March 29, 2024

Subject: Independent Review of Seismic Stability Analyses Performed by Geosyntec, Lake Petit Dam, Pickens County, Georgia (Schnabel Reference Number 23170093.000)

Figure 2: Deaggregation Plot for 2475-year Return Period, $T = 0.4$ s, Site Class C/D (USGS 2023 NSHM, beta version)

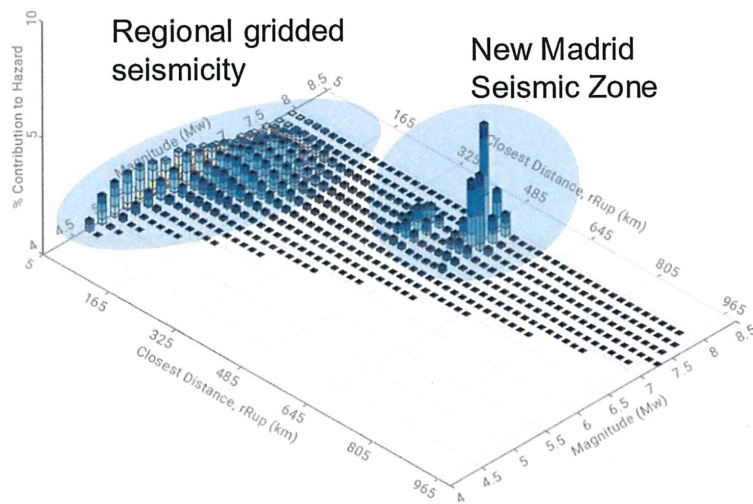
Geosyntec used M_w of 7.0, which is slightly larger than the mean M_w contributing to the hazard at $1.5T_s$. For discussion, Figure 2 shows the deaggregation plot for 2475-year return period, 0.4 s vibration period, site class C/D obtained from the online tool for the USGS 2023 NSHM (beta version). Figure 2 is similar to the equivalent plot for the 2018 NSHM, which has not been included for brevity. Figure 2 indicates that the hazard is influenced by regional gridded seismicity and the further distant New Madrid Seismic Zone. Although a few M_w and distance (R_{rup}) bins for the New Madrid Seismic Zone have the largest individual contribution to the hazard, the cumulative contribution of the local gridded seismicity is significantly greater than the New Madrid Seismic Zone. In this context, M_w of 7.0 is slightly larger than the mean of the contributing M_w for the regional gridded seismicity and less than the contributing M_w of the New Madrid Seismic Zone. In our opinion, M_w 7.0 is a reasonable choice for the 2475-year return period hazard because it is about equal to the overall mean M_w for the hazard. Further sensitivity analyses to assess the effect of a greater M_w in line with earthquakes generated in the New Madrid Seismic Zone, remembering that these earthquakes produce ground motions with smaller contribution to the hazard than the contribution of those produced by regional gridded seismicity, are not likely to alter conclusions reached by Geosyntec.

Figure 3: Undrained Shear Strength Characterization

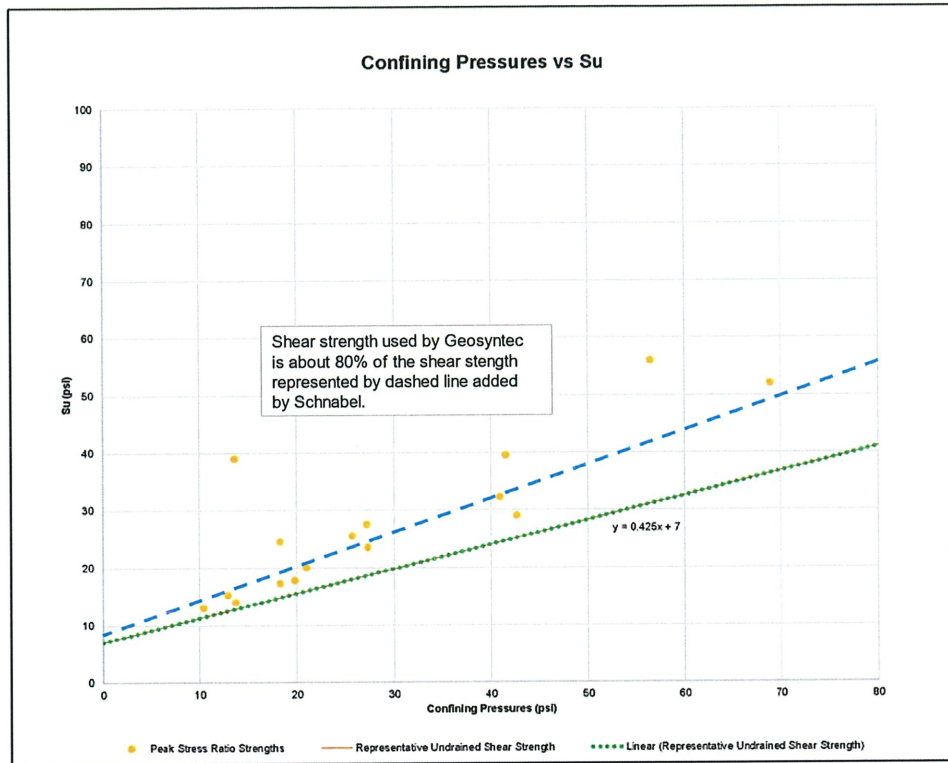
Neither Bray and Travasarou (2007) or (2009) mention a specific strength reduction factor, but in our opinion, it is typical practice to select conservative undrained shear strength parameters. Figure 3 shows that Geosyntec selected a lower bound undrained shear strength based on their laboratory data. For reference, the dashed line shown in Figure 3 was added by Schnabel at 1.25 times the Geosyntec strength (i.e., the Geosyntec strength is 80% of the dashed blue line). Visually, the dashed blue line appears to be a reasonable fit to the laboratory data, which suggests that Geosyntec’s undrained shear strength characterization is generally consistent with the dynamic yield strength recommended by Makdisi and Seed (1978).
